Attached should be additional information provided by North Delta Engineering and Pickering Engineering regarding the building. North Delta was asked to view the building from the perspective viewpoint of city ordinances for condemnation. Pickering provided a second opinion on the full structure from a stability standpoint.

ADDITIONAL ENGINEERING EVALUATION ITEMS

Building Location: 100 W. Washington Ave., Jonesboro, AR

**Structural Assessment
100 W. Washington Avenue
Jonesboro, AR 72401**

2. Bow at Widows and Trim

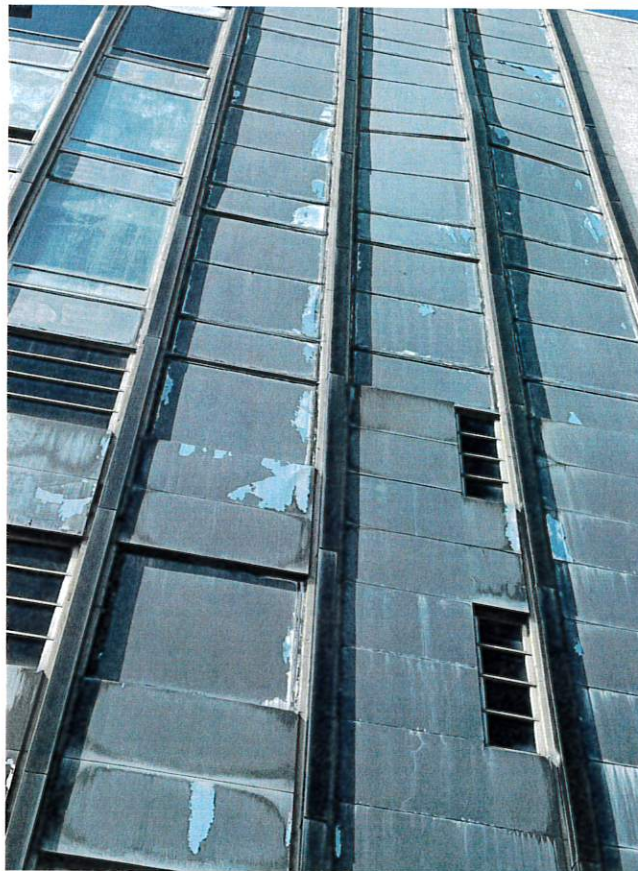
1. Trim between the windows appear to be bowing out (2).
2. Windows at sill appear to be separating from the floor; a gap is apparent (5, 6, 7, 10).
3. The attachment of the window sill to the floor edge appeared to be by means of concrete fasteners and the fasteners broke away from the floor (7)

1. The fact that few of the windows are bowing out may be an indication of loosening of the connection of the window frame to the building. This is evident at the sills of the windows that are visible.
2. It is not clear if and how the jambs of the widows are attached to the building structure.

1. Expose the frames of the windows and the porcelean panels by removing the trim at the outside of the building and the finish material at the inside in order to inspect the connections.
2. Expose the connection of the precast veneer to the building structure
3. Inpect the connections that are referenced above in order to verify adequacy and determine further action
4. Reinforce connections as required
